I have been retained by Little Lake Ranch (“LLR”) to assist in the evaluation of the environmental impacts that would arise from the pumping of groundwater to supply the Coso geothermal power plant (“Coso”) with reinjection water, and to address reasonable alternatives to the Project. My professional background is in geothermal power generating systems. I have attached a copy of my *Curriculum Vitae* to demonstrate my competency in commenting upon the matters set forth herein.

Previously I have submitted comments on the Draft Environmental Impact Report (DEIR). At this time, LLR has asked me to review and comment on two documents:

- A. **Coso Geothermal Power Project Conversion from Wet to Dry Cooling Evaluation, March 2, 2009, Power Engineers (“PE”).**
- B. **Letter dated March 3, 2009 to Mr. Chris Ellis, Coso Operating Corp., from Mr. Mehul Patel, Veizades & Associates.**

**Figure 1.** Coso-type plant equipped with a water cooling tower. Nomenclature: Same as Fig. 1 except: HPF, High-Pressure Flasher; LPF, Low-Pressure Flasher; GE, Gas Ejector; CP, Compressor; M, Motor; CN, Condenser; CT, Cooling Tower; P, Pump.

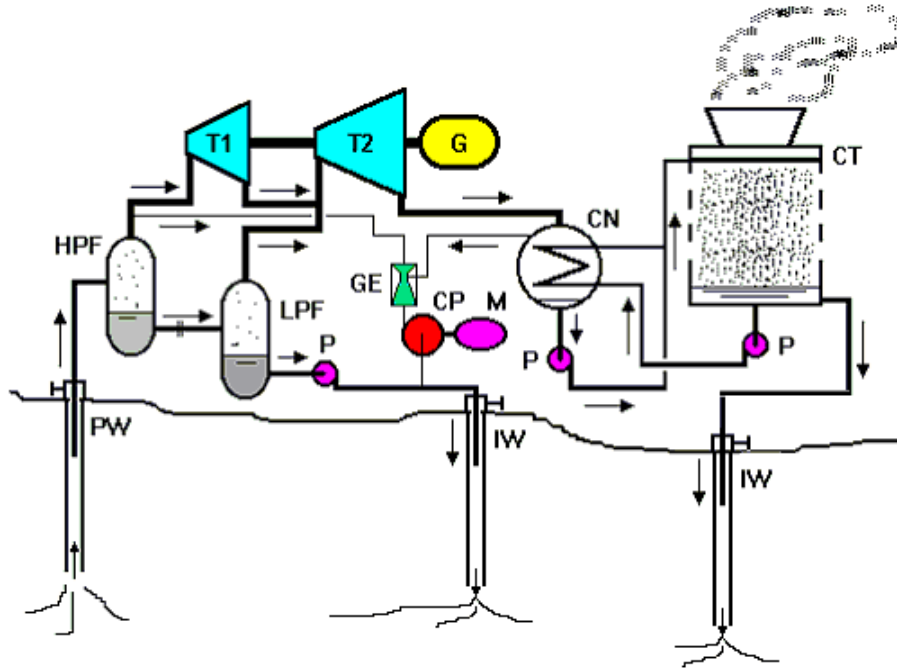
The purpose of the air-cooled condenser (“ACC”) is to replace both the existing condenser and the existing water cooling tower. To make this point in clear graphic terms, I include two diagrams from my DEIR commentary: See **Figures 1** and **2**. **Figure 1** shows the current operation with a water cooling tower. When the new ACC system is installed, the exhaust steam from the turbine would be sent directly to the ACC where it is condensed (**Fig. 2**).

There is no process flow diagram in the PE report, but from the text one can conclude that their design includes a new ACHE to replace only the water cooling tower. This error is amplified because their design requires the ACHE to produce cooling water at a temperature of 78.4°F, the same that is produced from the water cooling tower. Since the temperature in the existing condensers is 122°F and its corresponding pressure is 1.79 psia, according to the heat balance diagram used in the PE report, the new ACC needs to meet that temperature in order to maintain the same exhaust pressure. The additional 44°F of temperature drop that their system imposes will clearly render their system very inefficient, given the climate at Coso, but this is not the system that we have proposed to replace the existing system. As proposed by PE, the size of the ACHE would be overstated and its cost will be highly exaggerated. The PE report shows a lack of understanding of the function of an air-cooled condenser, or it may attempt to mislead the reader about more feasible design alternatives.
